1997 - 1999 Corvette: Service Bulletin: Loose or Missing Headlamp Door Bezel Plug

Subject: Loose or Missing Headlamp Door Bezel Plug (Install New Bezels and Plugs)

Number: 99-08-42-005

Models: 1997-99 Chevrolet Corvette

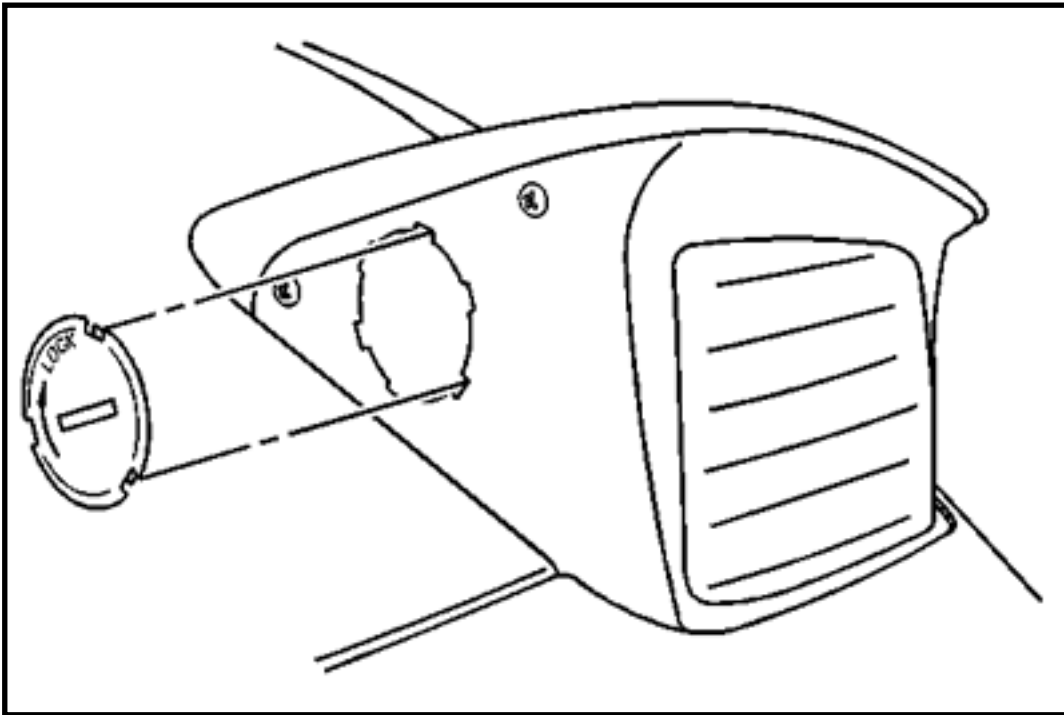
Some customers may comment that the plastic plug that covers the headlamp aiming adjustment screw on the inboard side of the headlamp door bezel is loose or missing.

Two different size plugs have been used in production. Early production 1997 vehicles used a plug with a diameter of 24 mm (15/16 in), while later 1997 vehicles and all 1998 and 1999 vehicles use a larger 54 mm (2 1/8 in) diameter plug. Both size plugs have been replaced by a new design plug and, therefore, will no longer be available.

Using the following service procedure, replace both the left and right headlamp bezels with the new design bezels that have a large NOTCHED hole. The notched hole is required for installing a new design NOTCHED plug.

1. Open the engine compartment hood.
2. Turn the headlamp switch to the ON position (the headlamp doors will open and the lamps will illuminate).
3. Turn the headlamp switch back to the PARK lamp setting (headlamp doors will remain open).
4. Remove and discard both the left and the right headlamp bezels and plugs, following the information in the Body & Accessories section of the appropriate Service Manual.
5. Install the new left and right headlamp bezels.
6. Align the notches on the new plug with the notches in the opening in the new headlamp bezel.
7. Using a quarter or a flat-bladed screwdriver, slowly rotate the plug in

the direction shown by the arrow on the outside of the plug until a click can be heard or felt.

8. Repeat steps 6 & 7 on the other headlamp bezel.
9. Turn the headlamp switch to the OFF position (headlamp doors will close).
10. Close the engine compartment hood.
